SIM 61 01 20

DELIVERY STOP: SAFETY BATTERY TERMINAL CONTROL LINE

This Service Information Bulletin (Revision 1) replaces SI B61 01 20 **dated February 2020**.

E-Series	Model Description	Production Date
F56	Cooper SE (All-electric BEV)	March 21, 2019 – December 10, 2019

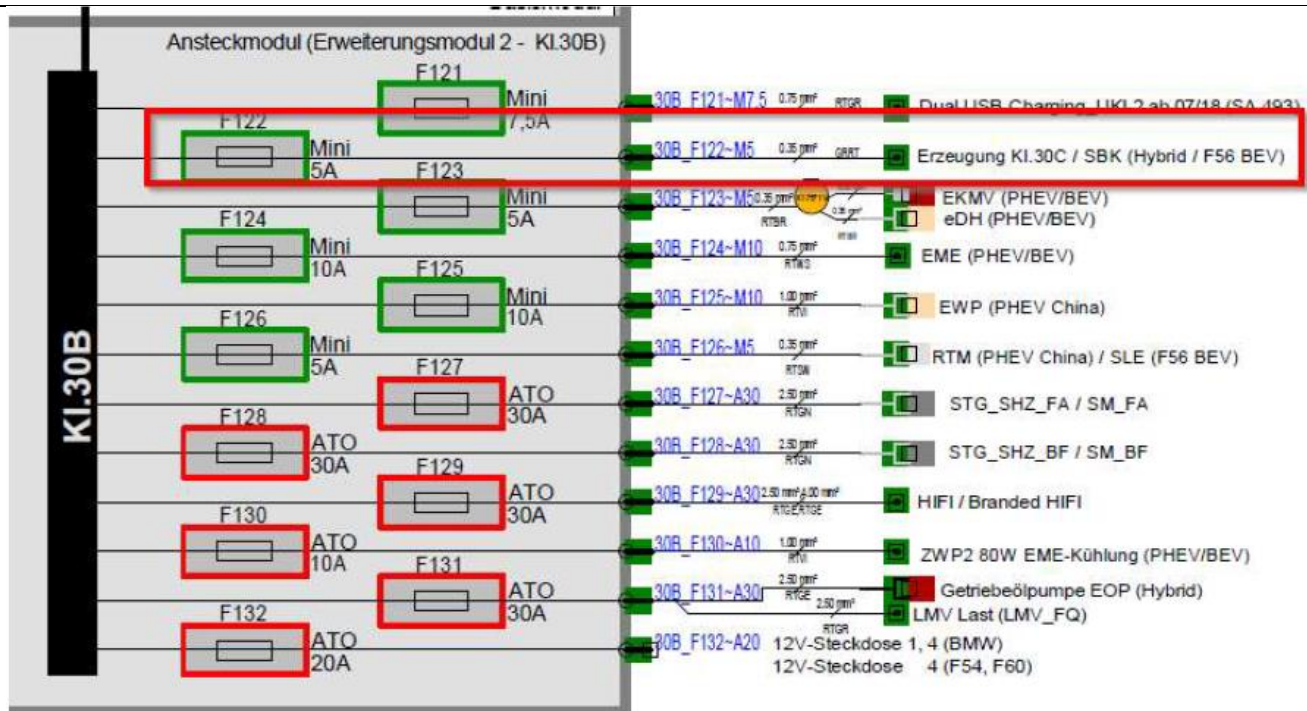
- Remove the front power distribution box as described in **'REP 61 14 ... R&I front power distribution box'** which can be found in AIR.

Power supply for the SBK is currently connected to fuse F122 (KL30B)

-SV top view-

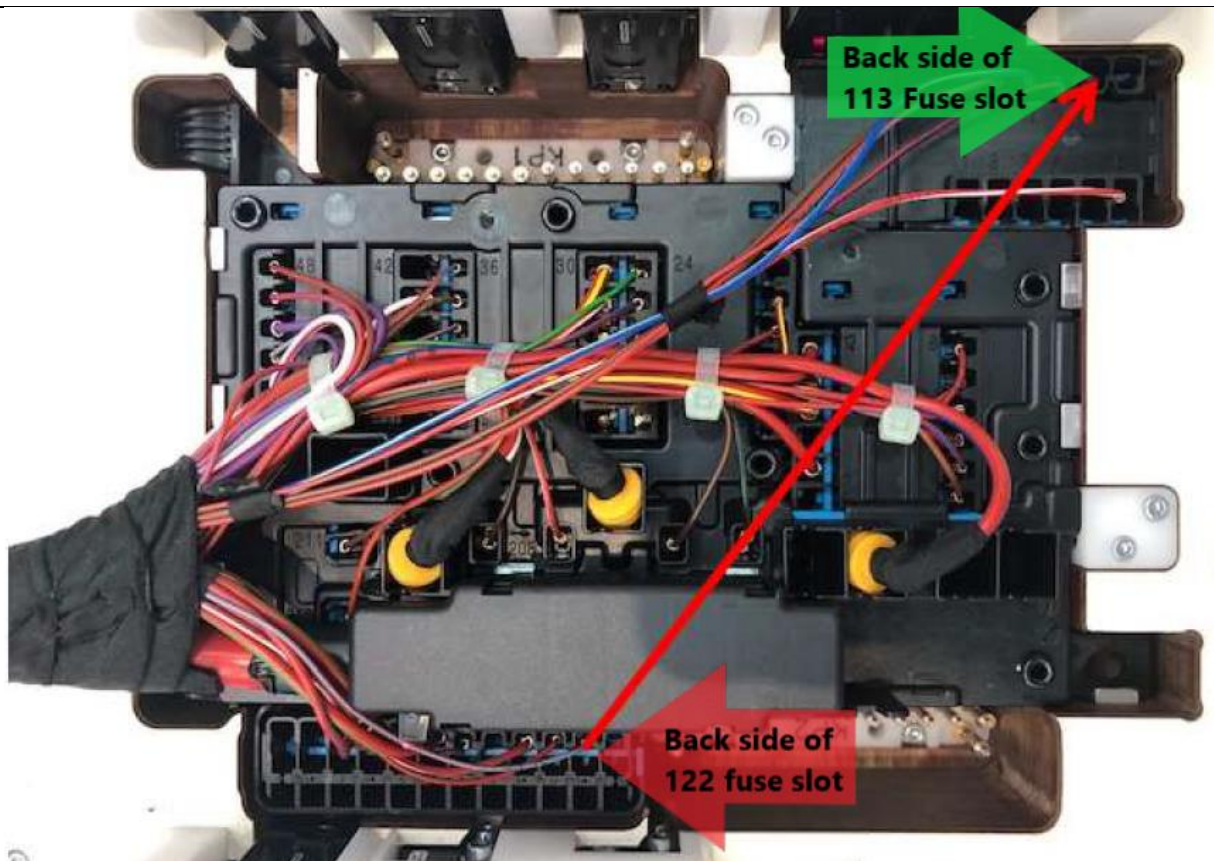
SBK power supply line needs to be extended and relocated to F113 (KL30F)

1. On connector Z7*9B pin 11 remove the GRRT (grey-red) wire.
 2. Remove fuse F122 (fuse will be placed later into slot F113)
- Cut connector off.

4. Secure newly routed wire with electrical tape to the existing wire harness as illustrated on the picture.
5. Arrow points current location (Fuse 122) to where the wire must be relocated (Fuse 113).
